**STEBENVILLE CITY SCHOOLS
SAFETY ENTRANCE RENOVATION****TO: ALL BIDDERS**

END OF ADDENDUM ONE

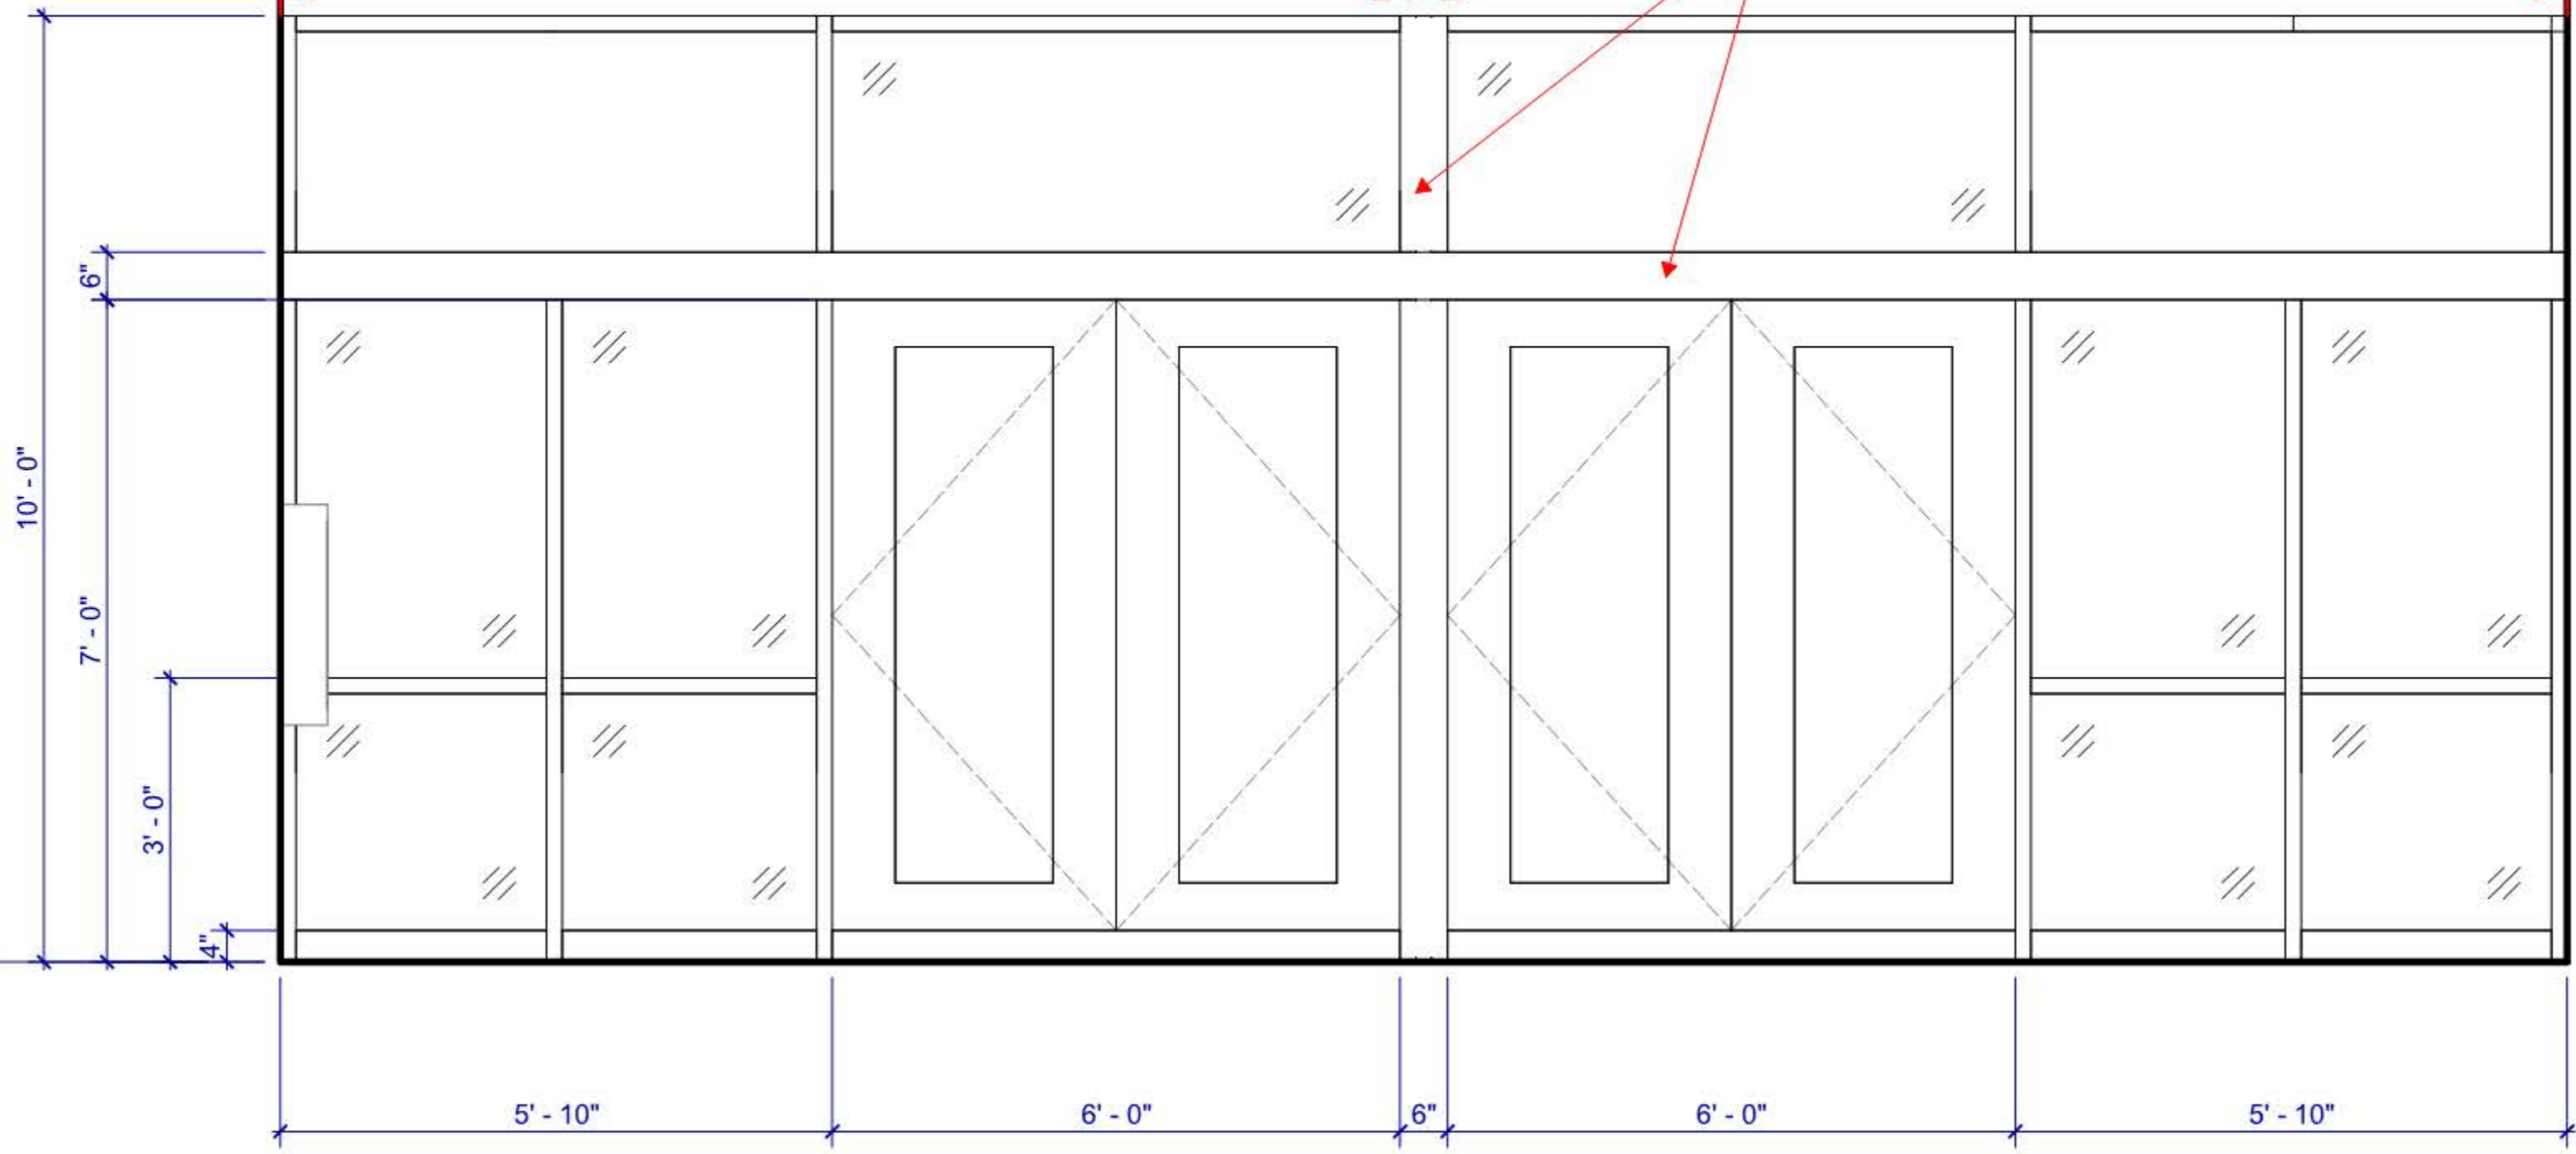
Question #2: Please see attached detail below asking for clarification of material.

EXISTING CONDUIT MOUNTED TO WALL

What material is this?

All material shown as part of the storefront entry system should be aluminum
to match the doors and frames
